AL KUT TRAINING ACADEMY
AL KUT, IRAQ

SIGIR PA-06-069
OCTOBER 18, 2006

SUBJECT: Report on Project Assessment of the Al Kut Training Academy,
Al Kut, Iraq (Report Number SIGIR-PA-06-069)

Site Photo 12. IP area cadet barracks.

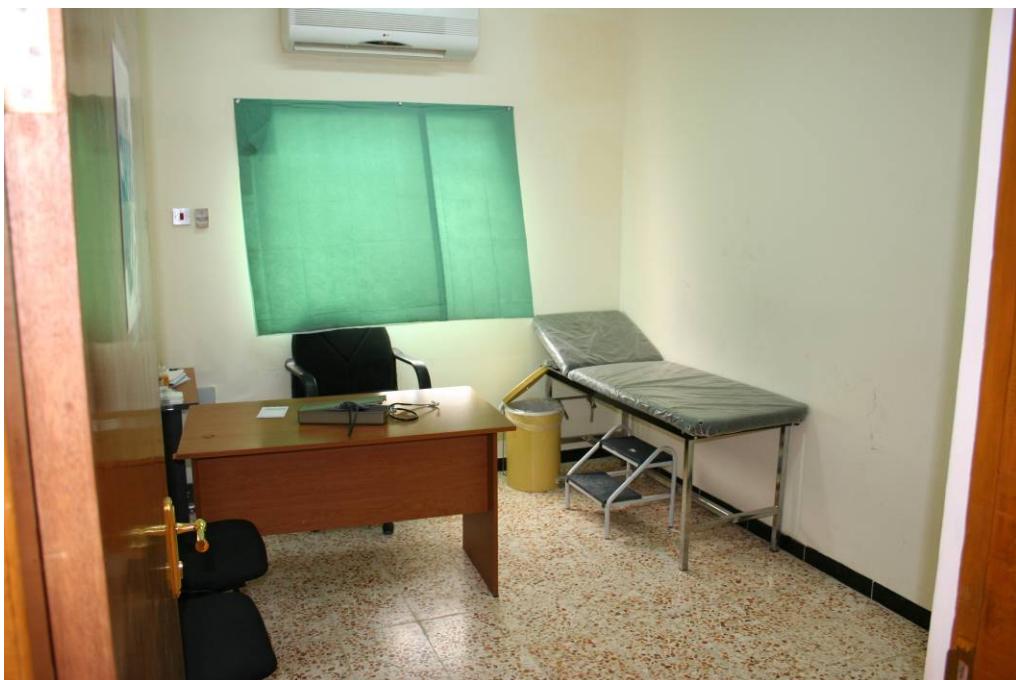
At the time of the assessment, most of the new building construction, renovation, and road construction was complete. While some lingering rework issues in a cadet dormitory precluded 100% operational capability at full capacity, those issues were pending complete resolution at the time of our site visit. The assessment team observed selected aspects of new construction and renovation work. They performed inspections of the cadet and instructor's barracks, classrooms, IP headquarters building, DBE headquarters building, clinic, and gymnasium. Site Photos 12 to 17 show some of their observations.

Many construction deficiencies, which ranged from minor to serious, were observed and photographed during the site visit. Examples included paint overspray on lights, windows, and door hardware; poor quality masonry work; crumbling concrete; improperly installed light fixtures and bathroom doors; exposed electric wiring; and poor quality hardware throughout the facility that was rusting or breaking after only a few months of use. Much of the observed workmanship and materials quality did
